Technical Bulletin

Model: SKS-C1			Date	e: 14-Oct-10	No.: RD108001a
RTB Reissue The items in bol	d italics have been cor	rected.			
Subject: Firmwai	re Release Note: Engine			Prepared by: M.	Ishihara
From: 2nd Overs	eas Tech Support Sec., 2nd	d PQM Dept.			
Classification:	Troubleshooting	☐ Part info	ormat	ion 🗌 Actio	n required
	☐ Mechanical	☐ Electrica	al	☐ Serv	ice manual revision
	☐ Paper path	☐ Transm	it/rece	eive 🗆 Retro	ofit information

Model: Shoukoushu-C1	Date: 01-Nov-10	No.: RD108002

Model: Shoukoushu-C1 D		Date: 14-Dec-10		No.: RD108003		
Subject: Parts of	catalog correction			Prepared by	/: I Sc	bh
From: 2nd Overs	eas Tech Support Sec. 2nd PC	QM Dept				
Classification:	☐ Troubleshooting	⊠ Part inf	orma	tion 🔲	Actior	n required
	☐ Mechanical	☐ Electric	al		Servi	ce manual revision
	☐ Paper path	☐ Transm	it/rec	eive \square	Retro	fit information
	Other ()				Tier2

SKS-C1 Part Catalog Page.33

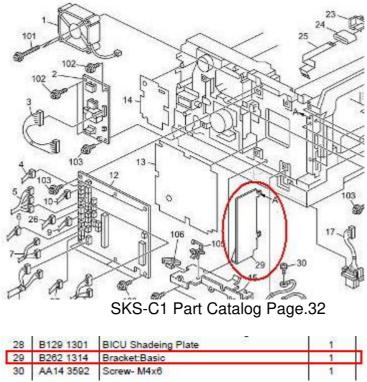
The part shown as follows does not really exist.

Erase all information about this part from the Part Catalog of SKS-C1.

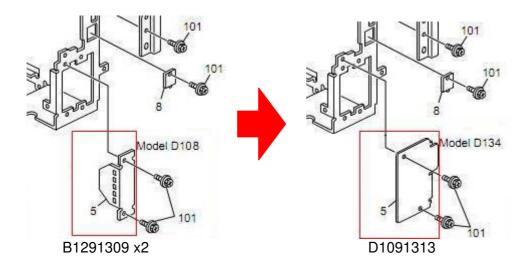
The GDI controller board and the shape of the interface cover were modified for use on the new D134.
